**REMARKS/ARGUMENTS**

Appl. No. 10/605,481  
Amdt. Dated November 10, 2004  
Reply to Office action of September 08, 2004

**Amendments to the Drawings:**

Fig. 2

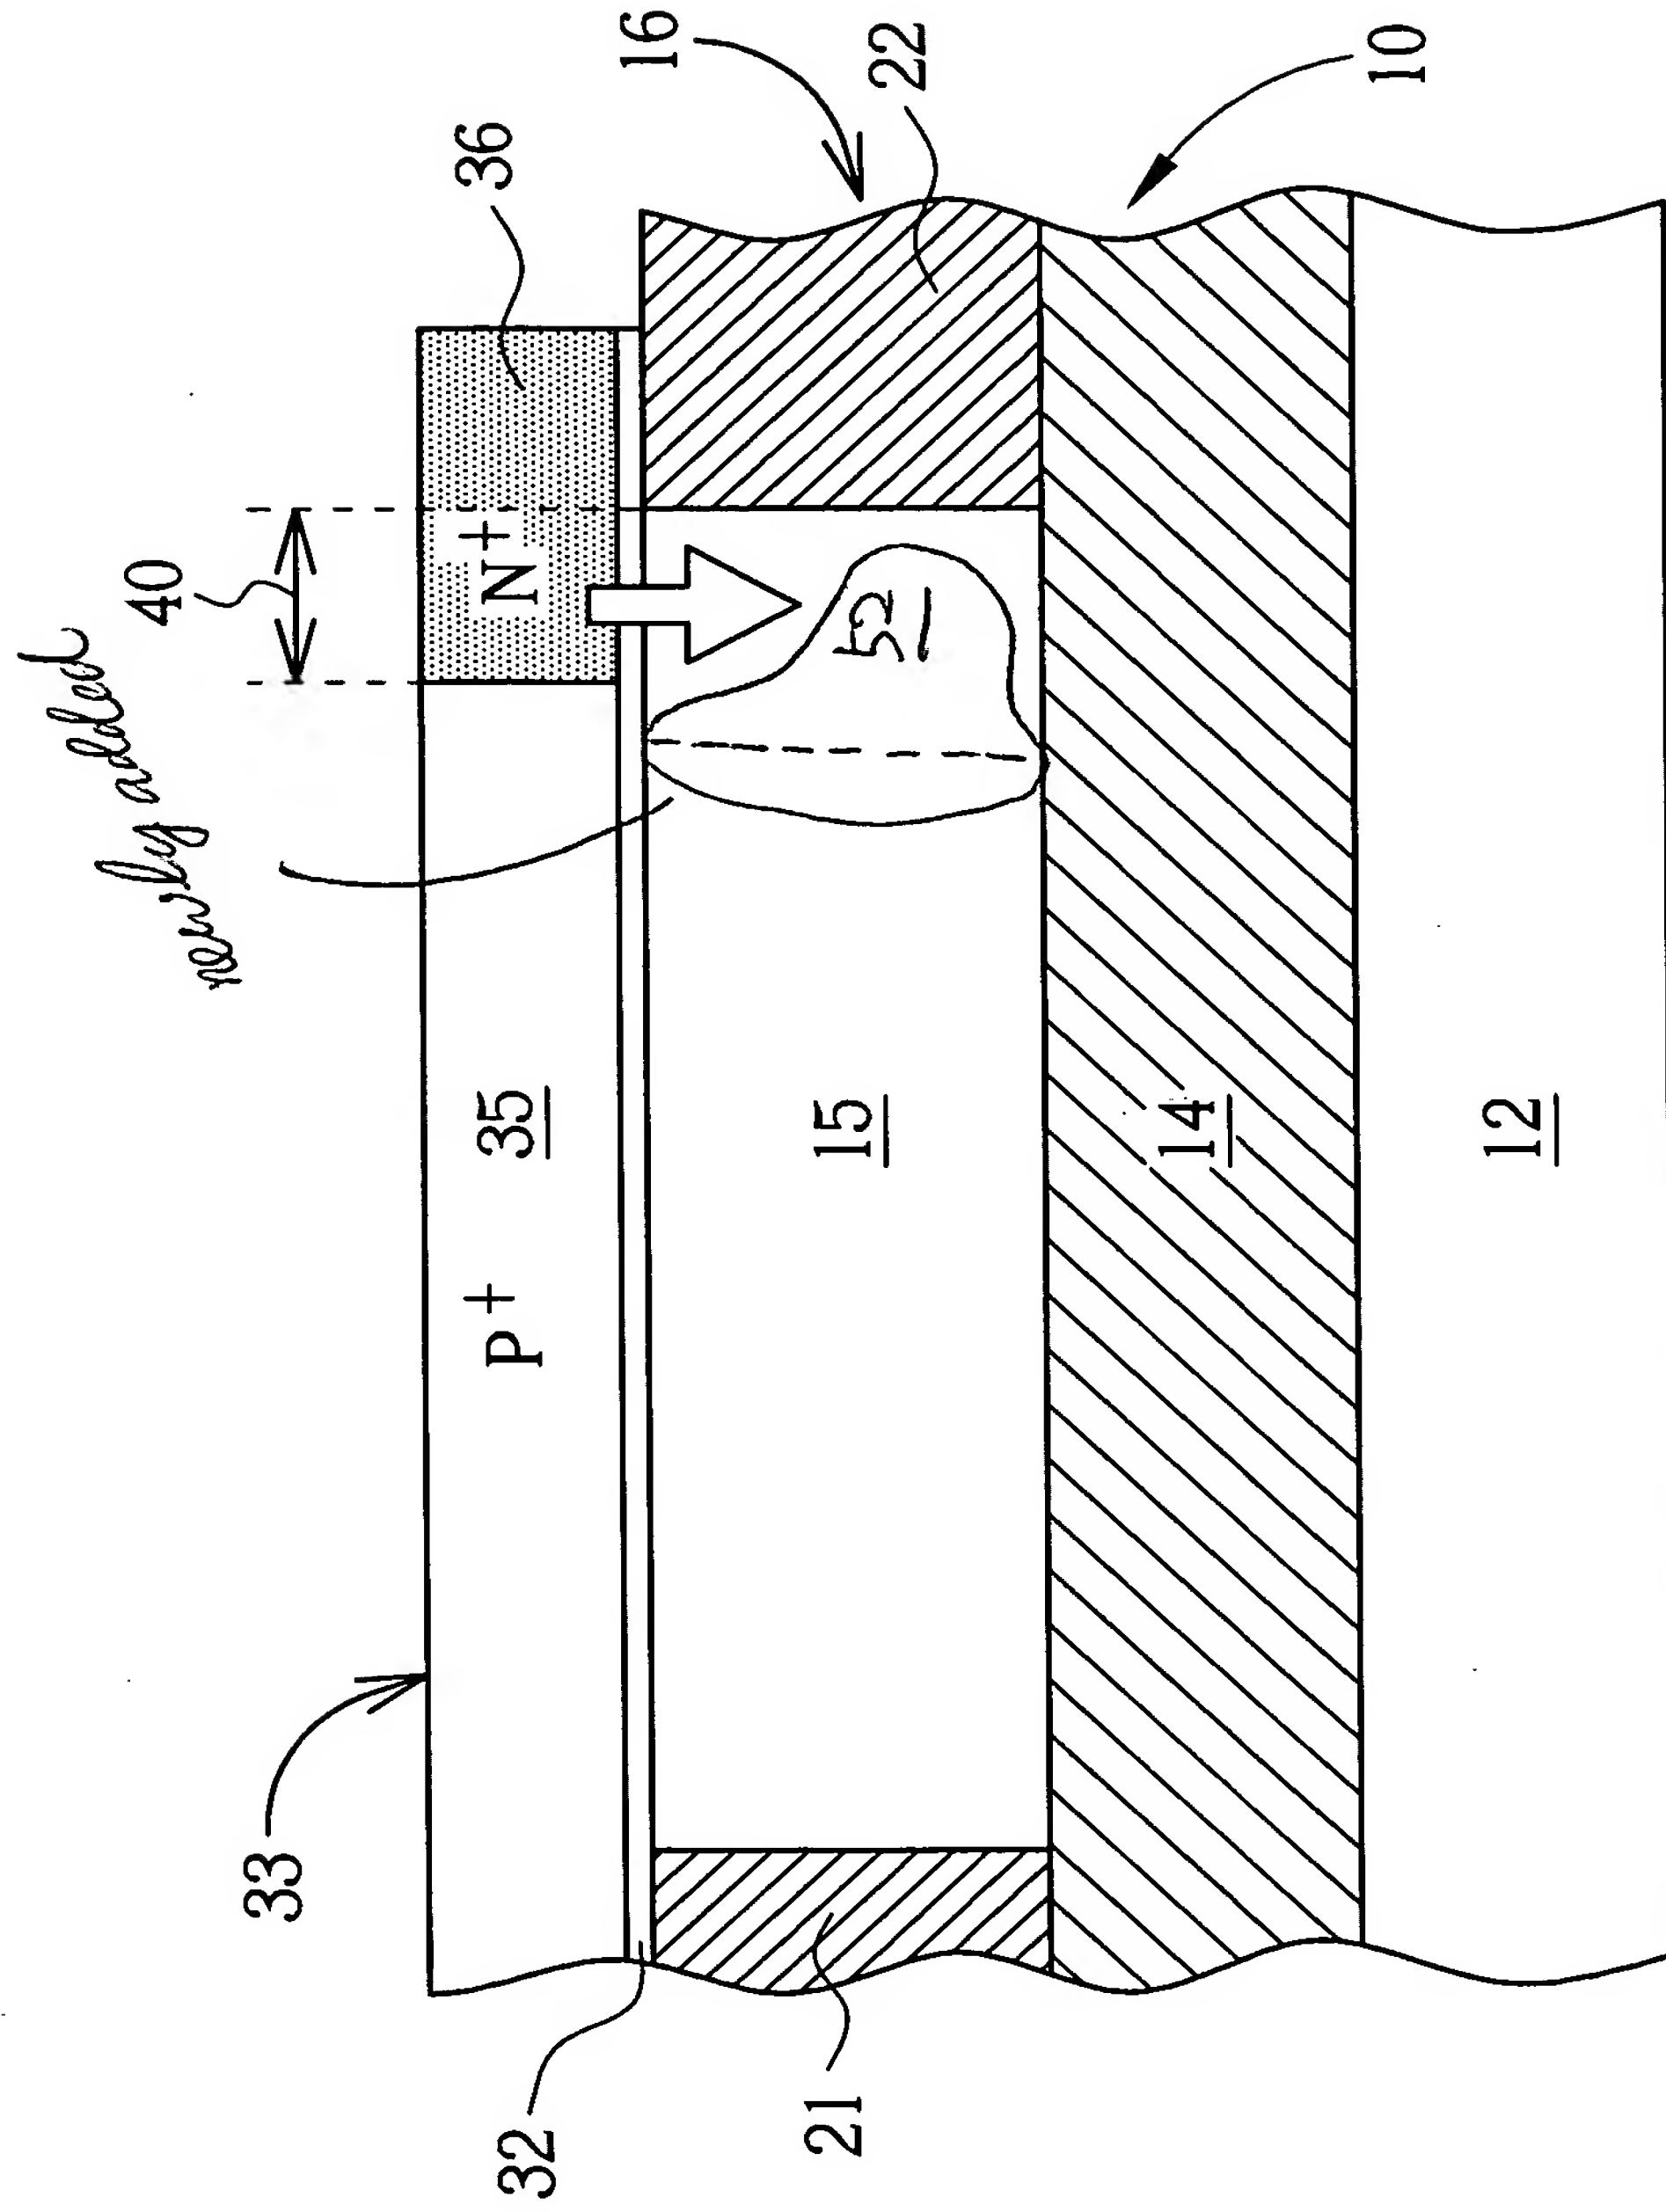
The Examiner further indicated that Fig.2 and Fig.4 disagree each other because Fig.2 discloses a tunneling connection between an extended  $N^+$  gate section 36 over a P-type electrically isolated body 15 in a P-type silicon thin film 16, while Fig.4 discloses  
15 the same tunneling connection wherein the extended  $N^+$  gate section 36 is now over a N-type extended body region 52.

For purposes of clarity, the reference numeral 52 has been added into Fig.2. However, applicants never teach that the electrically isolated body 15 is purely P type. In fact, as described in paragraph [0026], the electrically isolated body 15 is initially defined  
20 by STI regions and is fabricated within the N well 13. Therefore, the electrically isolated body 15 is N type before the source/drain 42 and 44 implant. As described in paragraph [0028] and also can be seen in figure 1, after the source/drain implant, the electrically isolated body 15 now includes channel region (N type) under the  $P^+$  gate 35, P type source/drain 42 and 44, and extended N type body region 52. It is respectfully noted that  
25 since figure 2 is depicted along line A-A of figure 1, the P type source/drain 42 and 44 is not shown in figure 2. Withdrawal of the objections to figures 2 and 4 is politely
